# Apalis iMX6

## Errata Document

Figure 1 Possible voltage divider workaround on Ixora V1.2

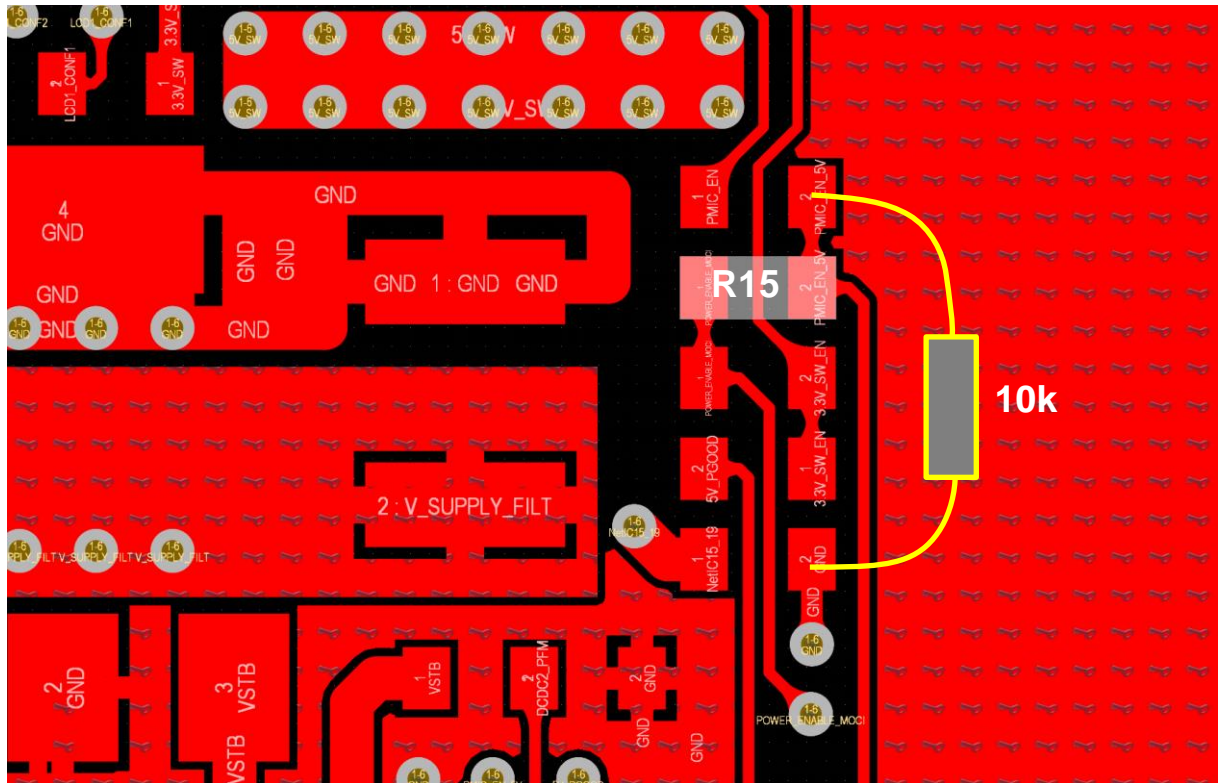
Depending on the carrier board and the amount of backfeeding, the POWER\_ENABLE\_MOCI might not go low enough to turn off the peripheral voltage rails in the shutdown state.

The POWER\_ENABLE\_MOCI signal is intended to be used for switching the peripheral voltage rails on the carrier board, like the 5V\_SW and 3.3V\_SW on the Ixora. Depending on the amount of backfeeding over the interface signals from the carrier board to the Apalis iMX6 module, the POWER\_ENABLE\_MOCI signal can remain between 1.0V and 1.4V in module shutdown. Depending on the carrier board circuit, this can be too high for turning off the peripheral voltage rails.

For example, on the Ixora V1.2, a different buck converter for the 5V\_SW is used than on the previous versions. The threshold voltage for the enable signal is lower on the new buck converter. Depending on the backfeeding level, the 5V\_SW buck converter does not get disabled in the shutdown state. The Ixora V1.0 and V1.1 are not affected by this issue since they have been using a different buck converter with a higher threshold.

Add a circuit to the carrier board for increasing the POWER\_ENABLE\_MOCI threshold voltage to between 2.0V and 2.5V. This could be achieved by adding a comparator or similar circuit. Such a solution is implemented in the V1.3 revision of the Ixora.

A simple voltage divider added to the POWER\_ENABLE\_MOCI signal can shift the voltage levels. Important: make sure that the minimum input voltage for enabling the buck converter is still guaranteed. With the AOZ2260 buck converter (which is used on Ixora V1.2), a 10k/10k voltage divider can be a suitable option. For patching such a divider, replace R15 with a 10k 0603 resistor and add another 10k resistor from the PMIC\_EN\_5V signal to the ground.
